**IEEE Std 497-2002**  
(Revision of IEEE Std 497-1981)

# Errata to IEEE Standard Criteria for Accident Monitoring Instrumentation for Nuclear Power Generating Stations

*Correction Sheet*

**Issued 20 February 2003**

**Figure 1— Display channel**

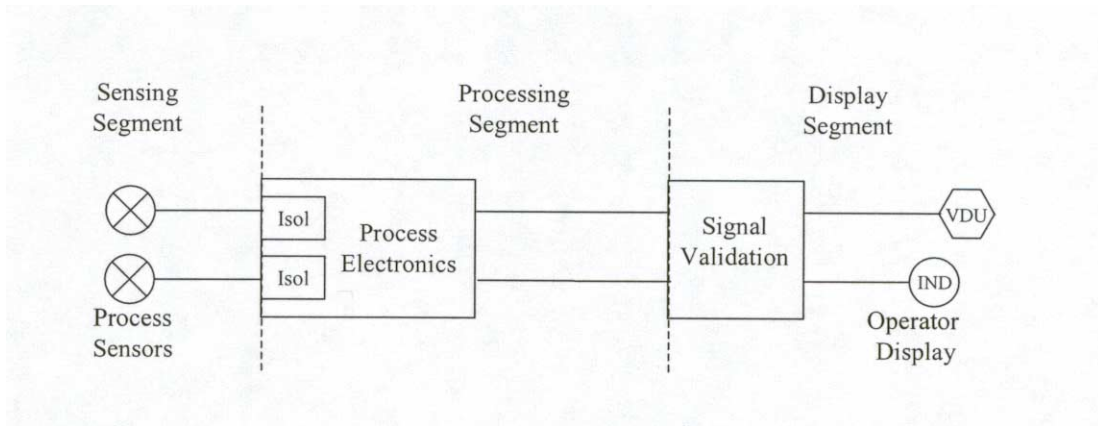
Page 5, Figure 1—Display channel, is incorrect. The figure should read as follows:

Figure 2—Examples of monitoring channel displays

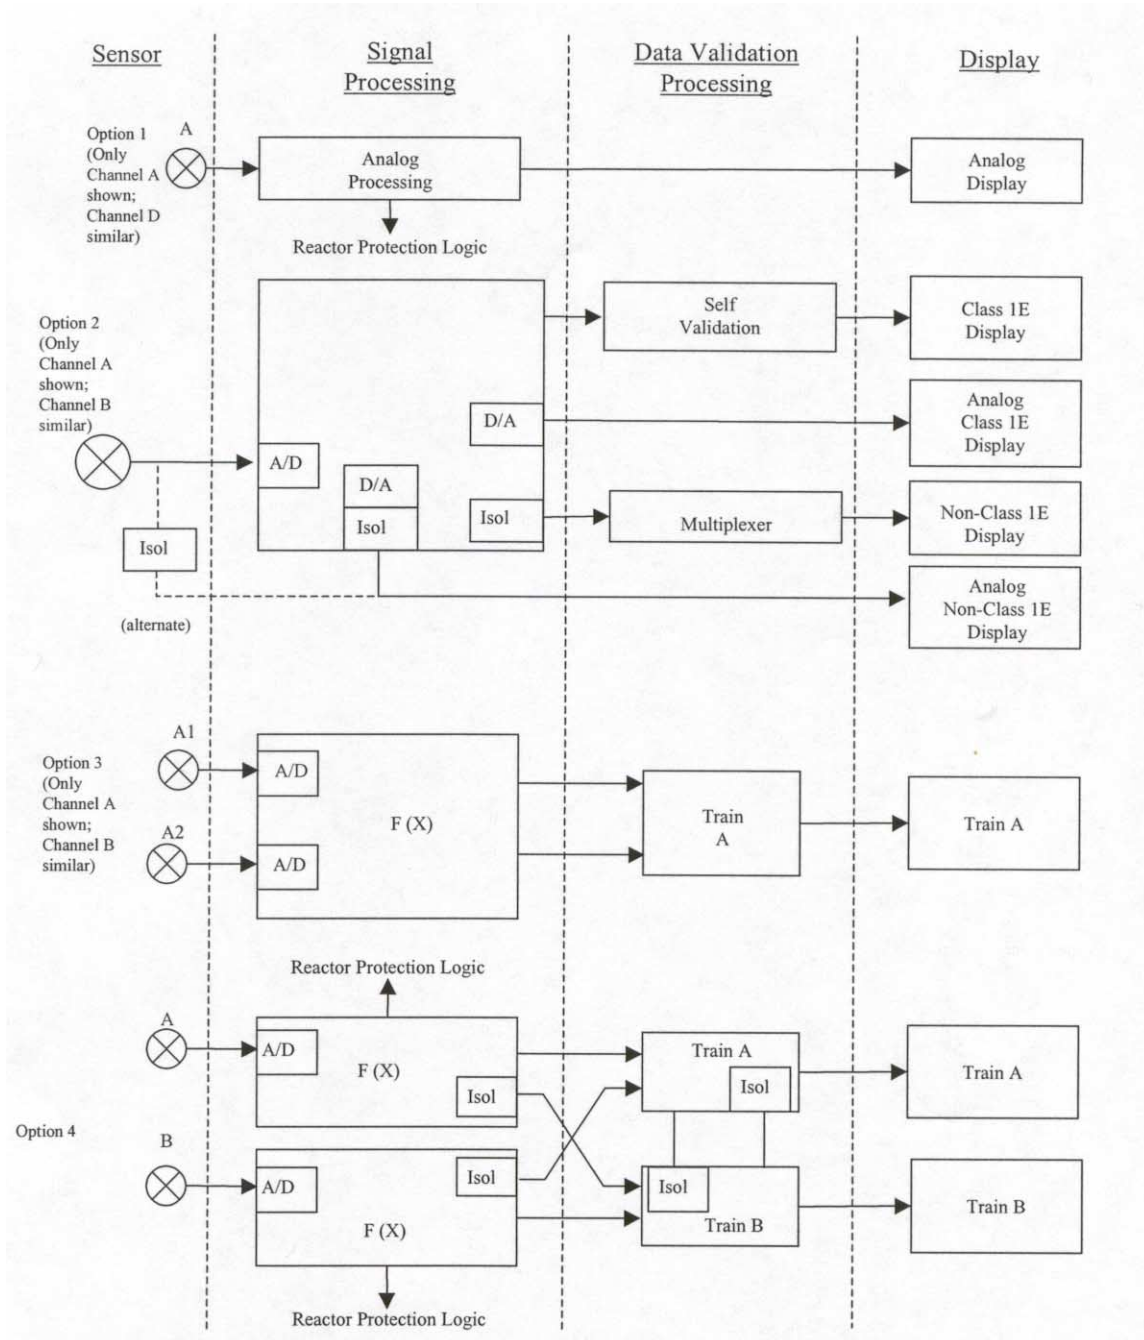
Pg 16, Figure 2— Examples of monitoring channel displays, is incorrect. The figure should read as follows.
